REF: SUP25-0006
DATE: March 13, 2025

Request - Special Use Permit for a Gas Station

Location - 1565 Alexis Road

SPECIAL USE PERMIT
TOLEDO PLAN COMMISSION
REF: SUP25-0006
DATE: March 13, 2025
TIME: 2:00 P.M.

SITE LAYOUT PLAN

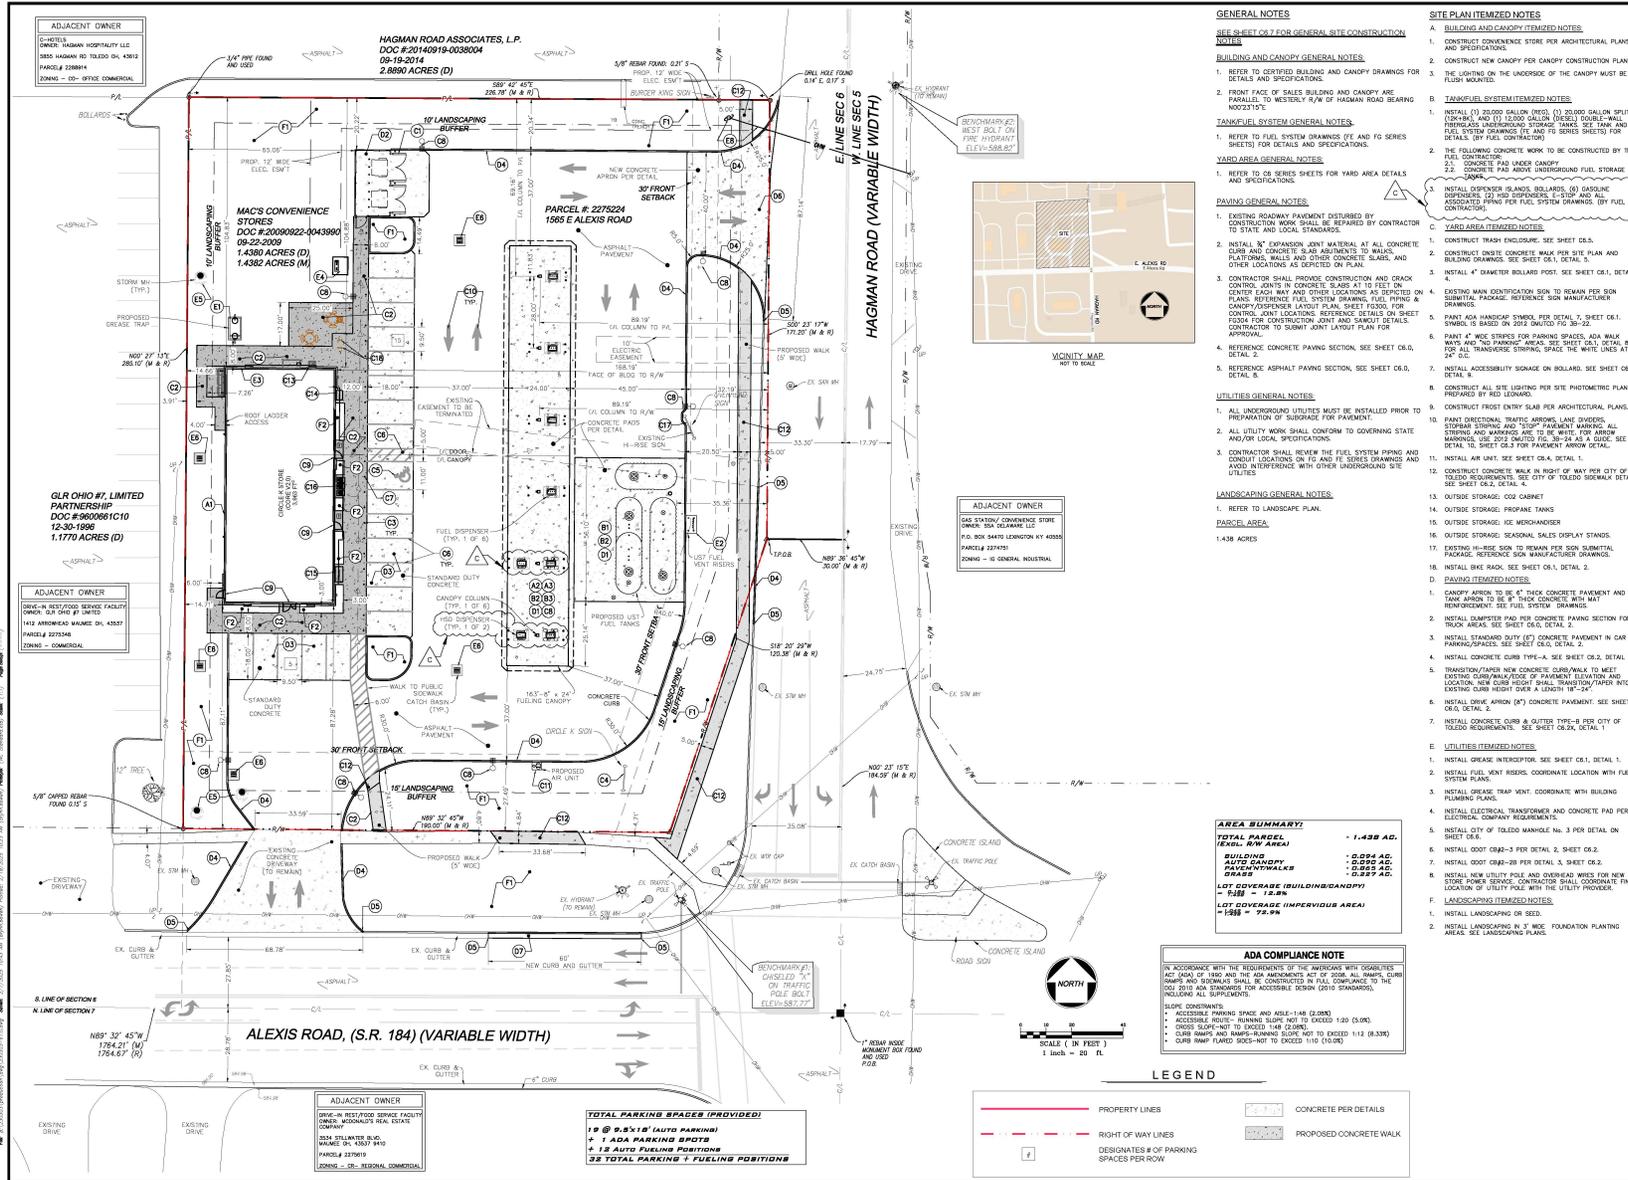
- a. The site plan meets the required minimum parking spaces (20 of 14 required), plus the 12 parking spaces at the pumps.
- b. Bicycle parking spaces are missing on the site plan. Per TMC§1107.0304, one space per 10 parking spaces shall be provided. This equates to four bicycle parking spaces. The Division of Transportation also set this condition.

- c. Per TMC §1109.0204(A) – Connecting Walkways, a pedestrian walkway from the right-of-way to the primary entrance is required. The walkway shown on the site plan goes from Alexis Road the principal building which faces Hagman Road. Given the site’s configuration, an alternative cannot be determined without significant changes to the site plan.

ELEVATIONS

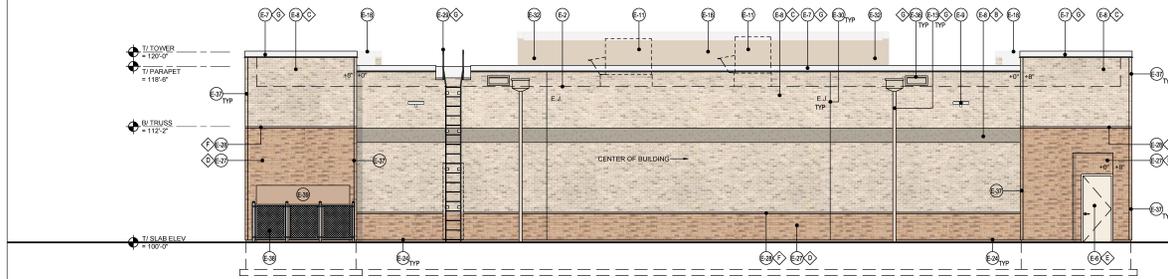
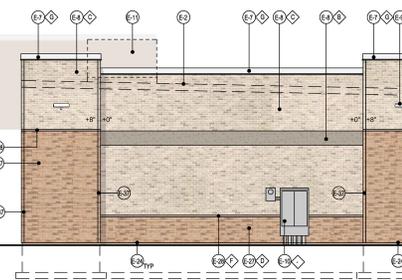
- a. The primary entrances face Hagman Road. On the East Elevation, the windows exceed the required forty percent (40%) of the elevation at grade. The South Elevation, which faces Alexis Road, does not meet the required twenty percent (20%) transparent window coverage. The window left of the doorway shown on the South Elevation is made of opaque spandrel glass.

- b. The building materials shown in the elevation are not acceptable, as the elevations depict Nichiha as the predominant façade material. This is not permitted beyond twenty (20) percent. The window coverage is not acceptable as stated above.
